REVISION 003 TO A INVITATION TO TENDER

Title - Sujet : Fort Wellington NHS – Eastern Palisade Rehabilitation, Fort Wellington National Historic Site		
Solicitation No. - N° de l'invitation : 5P468-22-0149/A	Date : November 24, 2022	
Amendment No. - N° de modification : 003		
Client Reference No. - N° de référence du client : 1175		
GETS Reference No. N° de référence de SEAG : PW-20-01008805		
Solicitation Closes - L'invitation prend fin : At - à : 2:00 PM On - le : December 1st, 2022	Time Zone - Fuseau horaire EST - HNE	
F.O.B. - F.A.B. : Plant - Usine : <input type="checkbox"/> Destination : <input checked="" type="checkbox"/> Other - Autre : <input type="checkbox"/>		
Address Enquiries to - Adresser toutes demande de renseignements à : Christine Piché		
Telephone No. - N° de telephone : 873-355-8841	Fax No. -N° de télécopieur : 1-855-983-1808	Email Address – Courriel : Christine.piche@pc.gc.ca
Destination of Goods, Services, and Construction - Destination des biens, services, et construction : See Herein

AMENDMENT 003

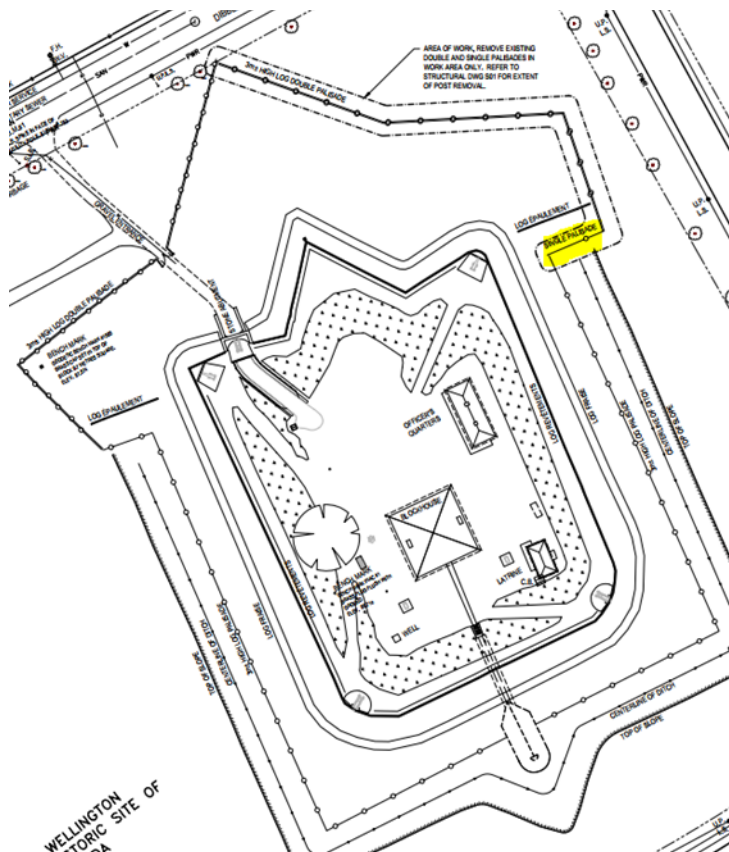
Q2. Is the portion of palisade running in the East-West direction to be single-type or double-type palisade?

R2. Section of palisade running in the East-West direction (approx. 15m in length) is to be a double-type palisade. (Section is highlighted in yellow below.)

Please see revised combined price table, drawings and details to that effect.
